**STATEMENT OF PETER AMES EVELETH
GENERAL COUNSEL, OFFICE OF COMPLIANCE
BEFORE THE SUBCOMMITTEE ON THE LEGISLATIVE BRANCH,
HOUSE APPROPRIATIONS COMMITTEE
July 8, 2008**

Capitol Visitor Center
Office of Compliance
Pre-Inspection

Office of Compliance CVC Pictures

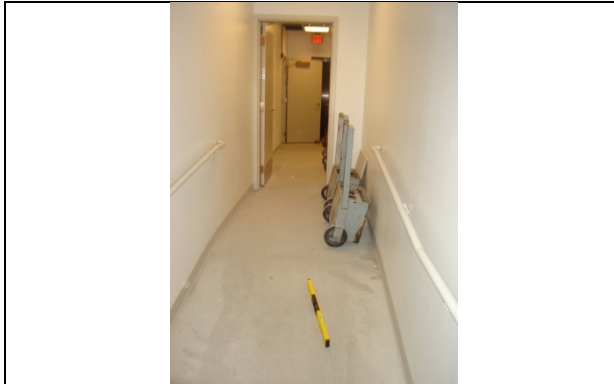
Hazard: Protruding handrails create projection hazard not compliant with 29 CFR § 1910.23(e)(5)(i), 2000 NFPA 101 7.2.2.4.5, ANSI/ASSE A1264.1-2007 Section 5.8 and ASTM E 985-00 Section 4.3.2.

Hazard: Outlets are not protected with Ground Fault Circuit Interrupters, which are required in kitchens due to wet floors by 1999 NFPA 70E Section 110-10.
Solution: Install low cost GFCI outlets in the kitchen and near all water sources.

Solution: Turn handrail end into the wall.
